FRAMEWORK BRIEFING -
RECORD OF UPDATES REQUIRED
AND RECORD OF MEETING

From: [REDACTED]
Sent: 16 May 2013 15:38
To: [REDACTED]
Cc: [REDACTED]
Subject: RE: LAMP overview / DRAFT record of agreements

LAMP Airspace Development
Framework Briefing: Record of Agreement
NATS ref: **4565/RPT/30**◇Issue 1

Figure 2: FAS schematic for meeting CAP&25 requirements for SID change

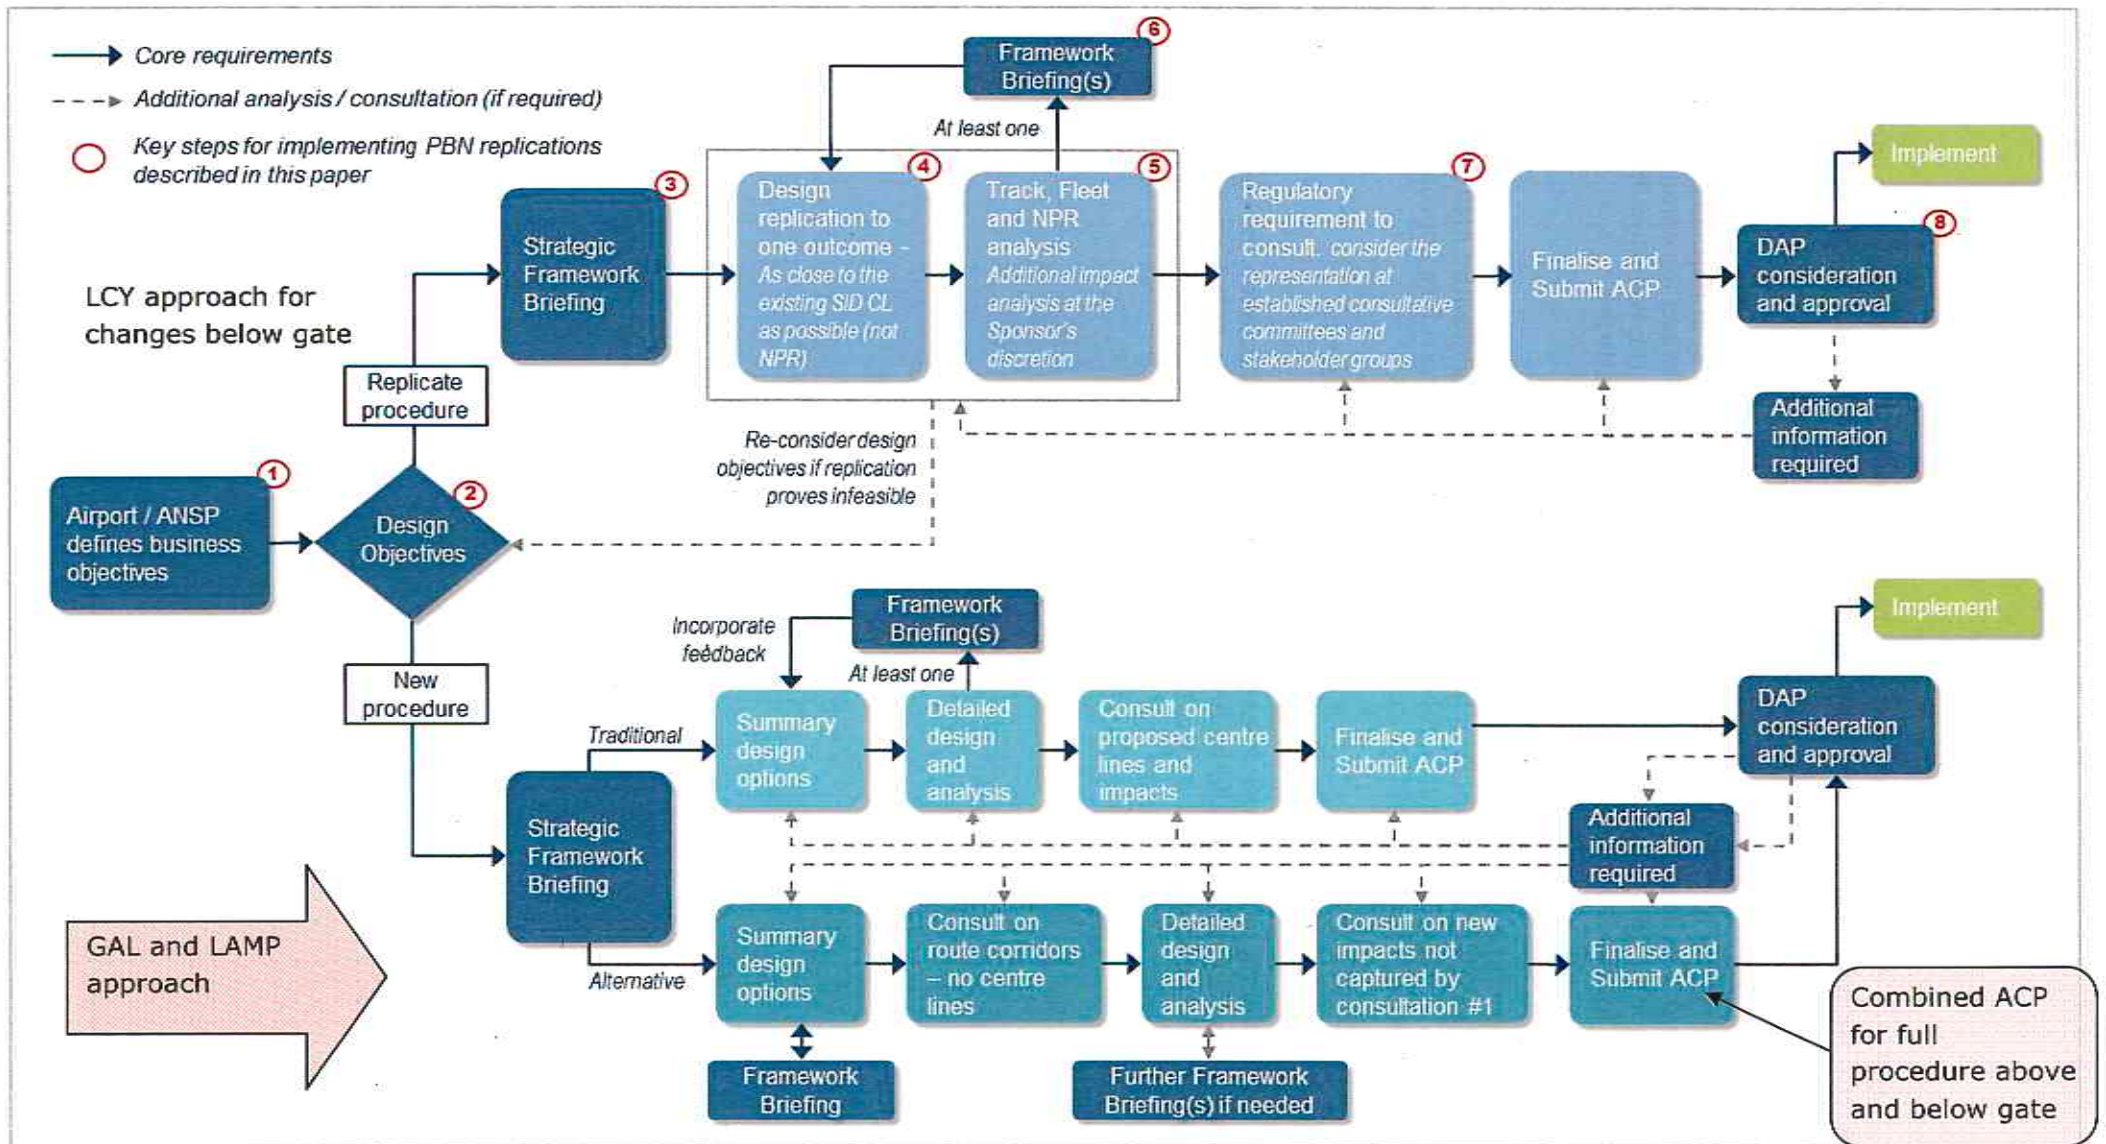
5. Para 4.3 – replace 'agreed through FAS' with: 'the CAA Policy Statement for Guidance on PBN SID Replication for Conventional SID Replacement (to be Issued mid 2013)'.

Figure 1: Hypothetical stage 2 swathes 0-7000ft

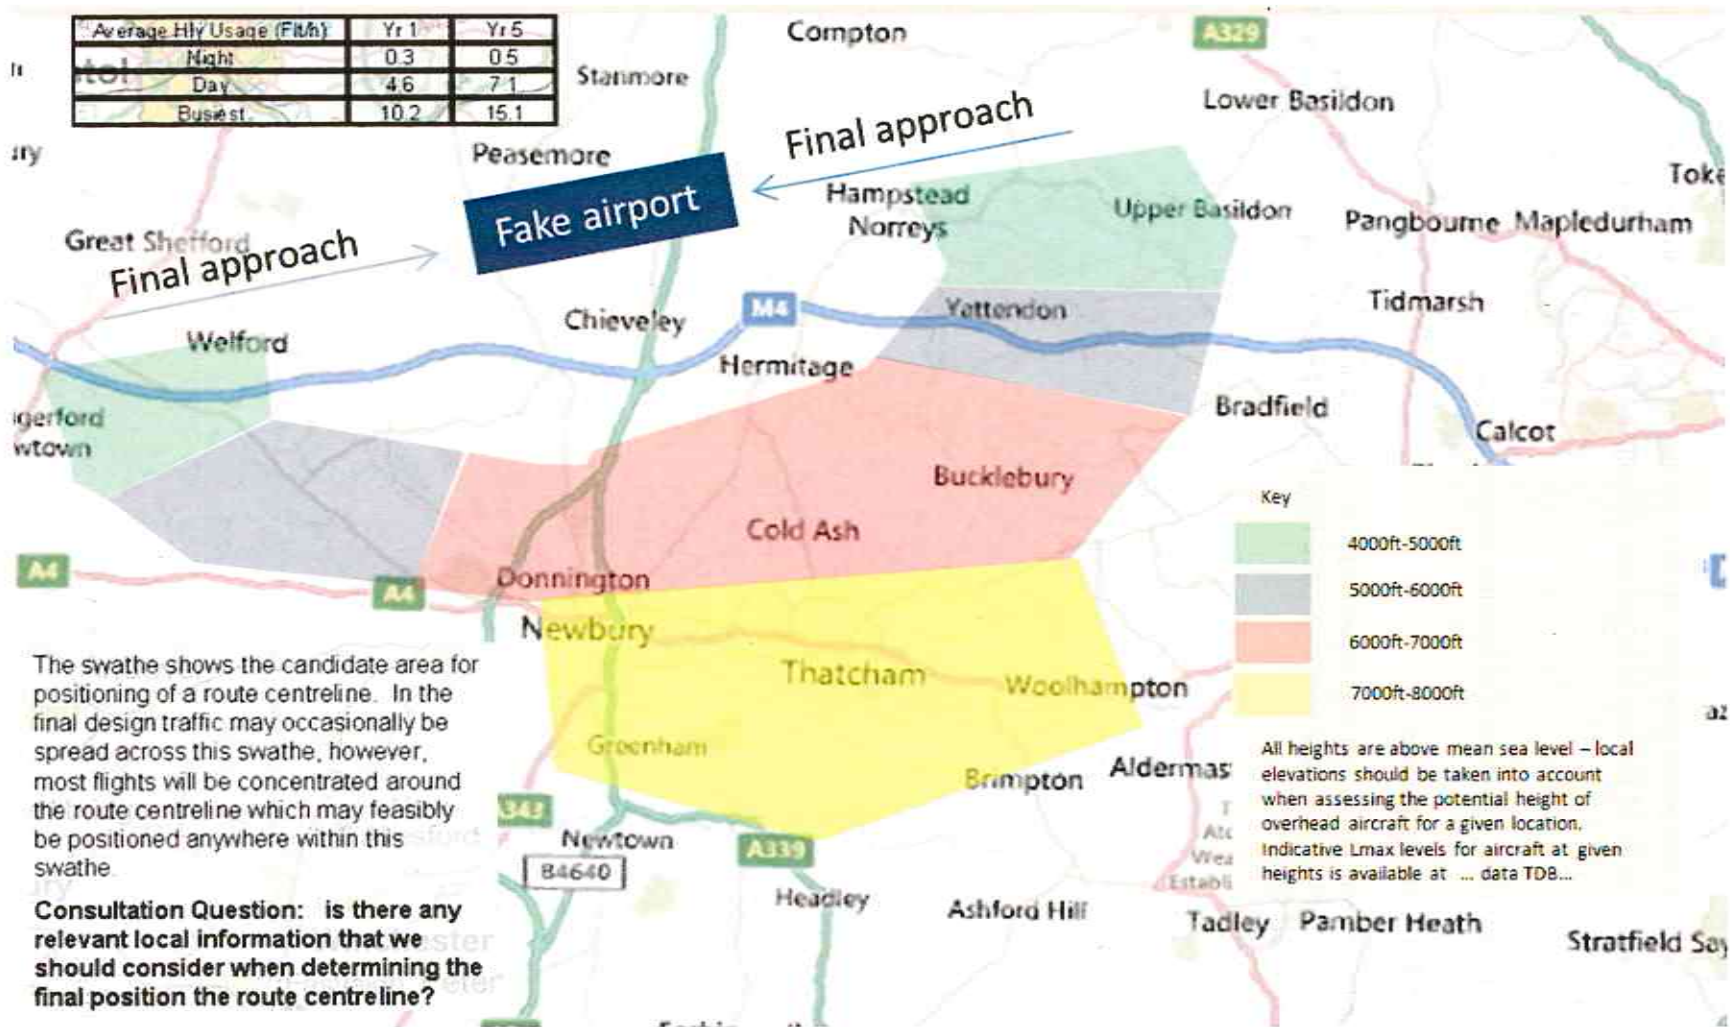
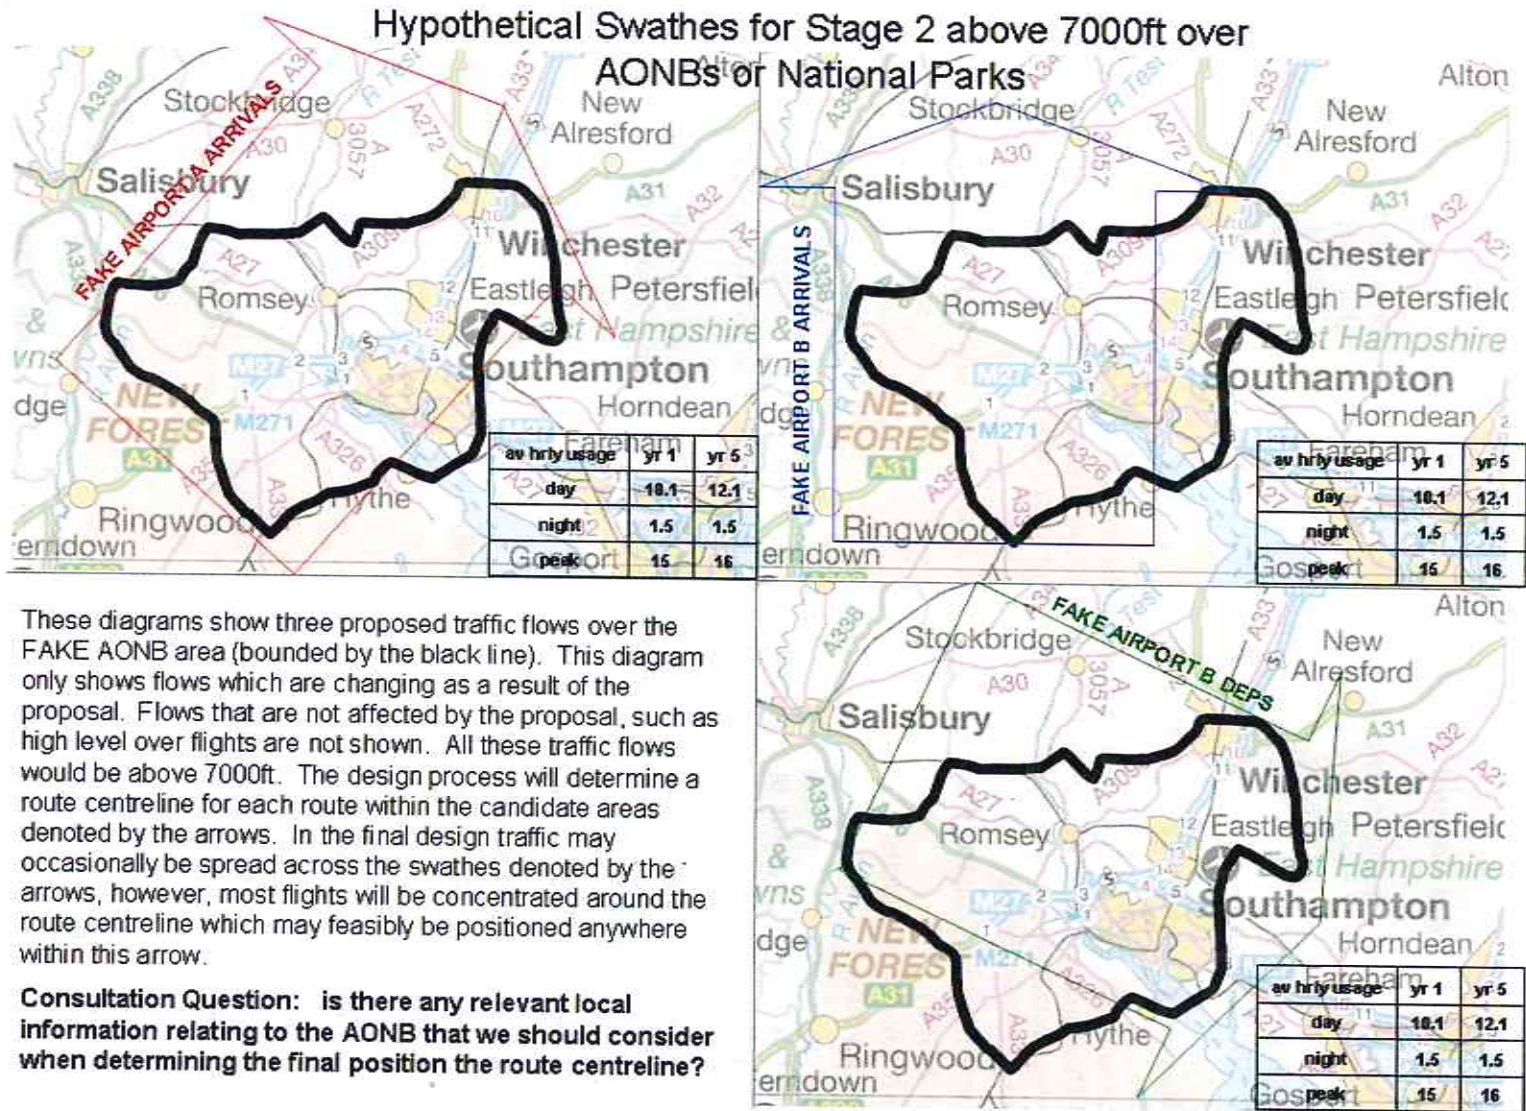
- Any assessment and/or consultation material that uses the "corridor" diagrams should be clear about the profile being used e.g. is it the lowest profile or an average profile. If using the lowest profile, then that should be made clear in any accompanying text.

- The diagrams must incorporate a buffer into the corridor, per email of 11 May 2012, so that the corridor reflects all options being considered plus a reasonable margin such that most (if not all) flights would be within the portrayed corridor.

- Corridor diagrams must include the tables that were shown in the example, i.e. frequency of flights and Lmax table for typical and noisiest.
